Staff Report
 PZ16-00013 (ZC, DEV)
 Village at Saddlerock Crossing
Summary Sheet: Conceptual Review

Meeting Date: September 28, 2017

Action Requested: Conceptual Review of Zone Change and Development Review Application

Project Summary: Conceptual Review of a mixed use project consisting of 126 lodging units (Oxford Suites), 12 condominium units, 5 employee housing units, a restaurant, retail space, a new public road, and associated site improvements and public amenities

SITEPLAN
7/11/ 2017

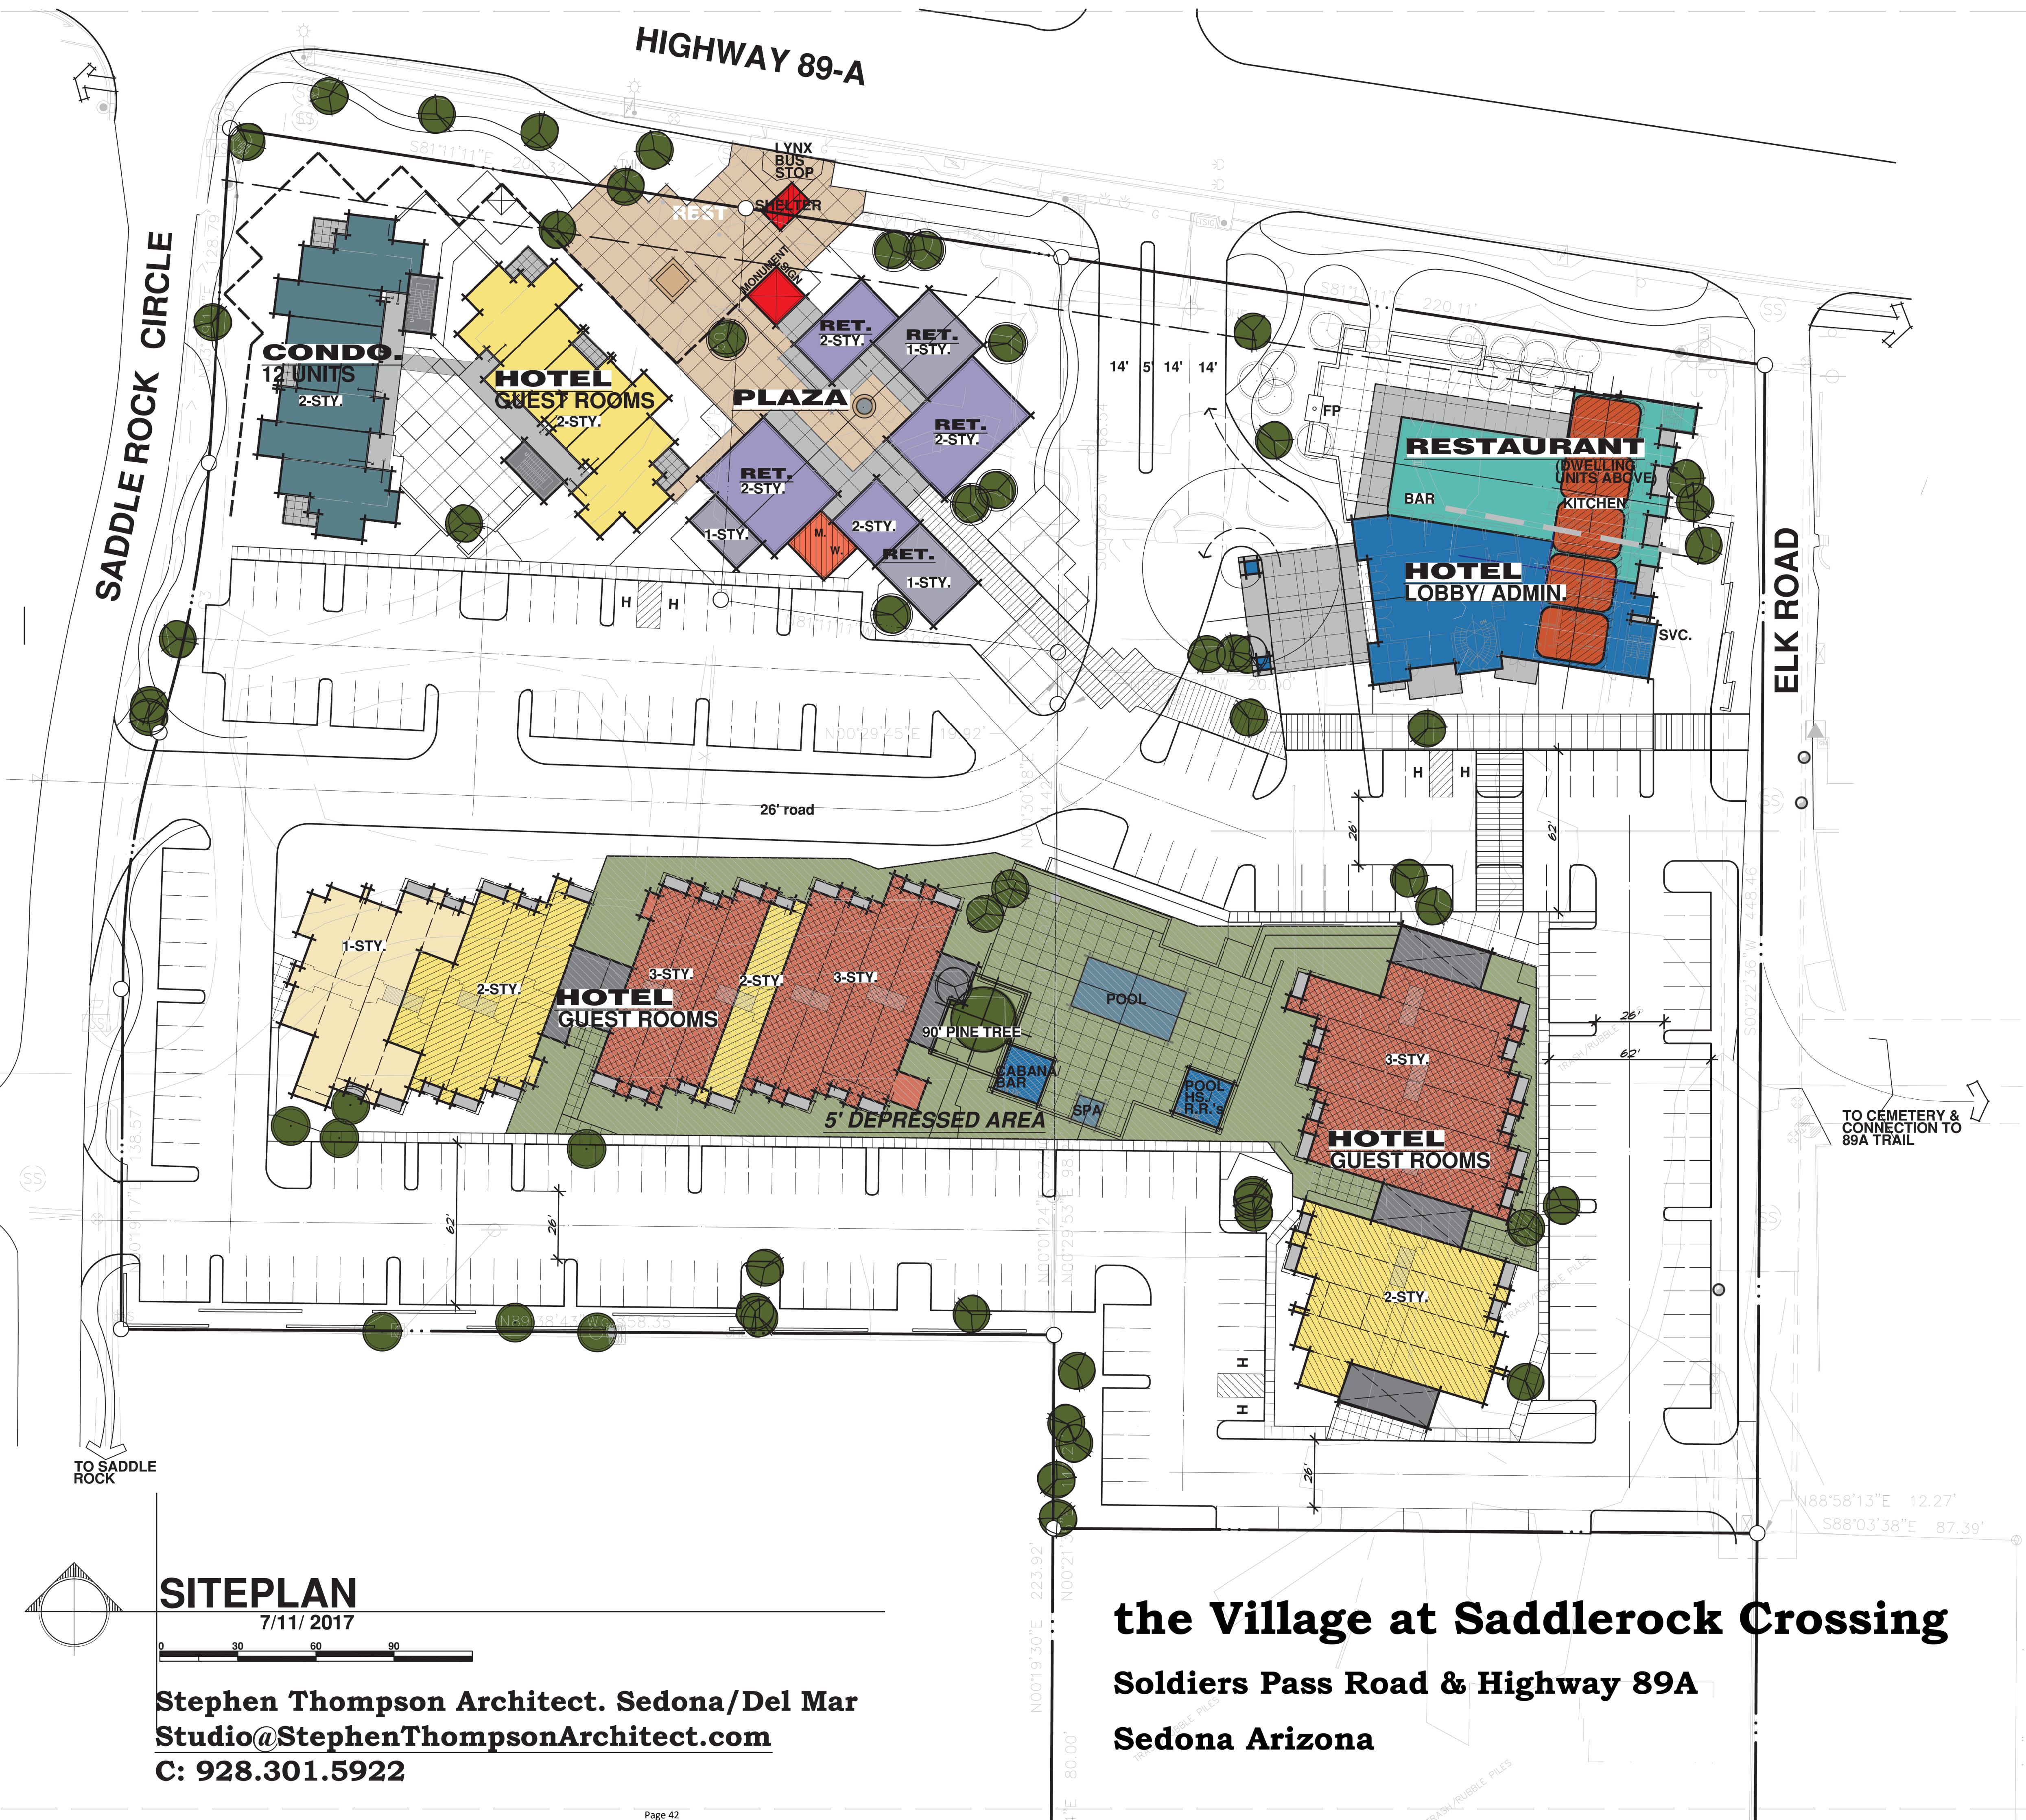
- The applicant has provided preliminary parking calculations resulting in a total requirement of 243 spaces. 215 parking spaces have been provided on site.
 - *Staff has asked for clarification on the parking calculations, as it does not appear that all proposed areas have been accounted for and it does not appear that the correct parking ratios were used in calculating parking.*
 - *Parking requirements may change based on requested clarifications regarding the number of lodging units and amount of retail/restaurant space.*
 - *The applicant has not provided any justifications for the discrepancy between the required parking and proposed parking.*
- *Parking must meet all applicable requirements of the Land Development Code (LDC 912). A complete review for compliance with these requirements will be completed during comprehensive review.*

- The site plan includes a 27 foot tall monument sign.
 - *The City's Sign Ordinance does not allow for a monument sign at this height.*
- *A master sign plan will be required for comprehensive review.*
